P&WC S.B. No. 41114R2

TURBOSHAFT ENGINE
INSULATION BLANKET - REPLACEMENT OF

PT6C-67C, PT6C-67C1

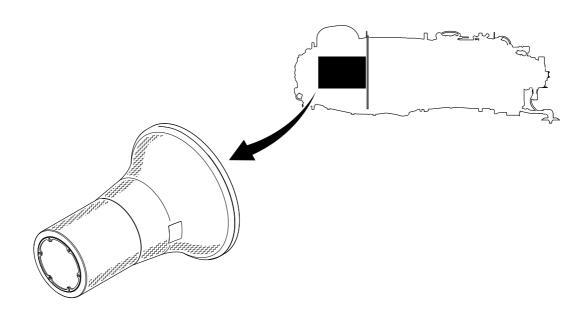
<u>Summary</u>: The insulation blanket may cause interference with the exhaust case and is difficult to produce. Replace the insulation blanket with one of varying thickness envelope for a

better fit and easier produceability.
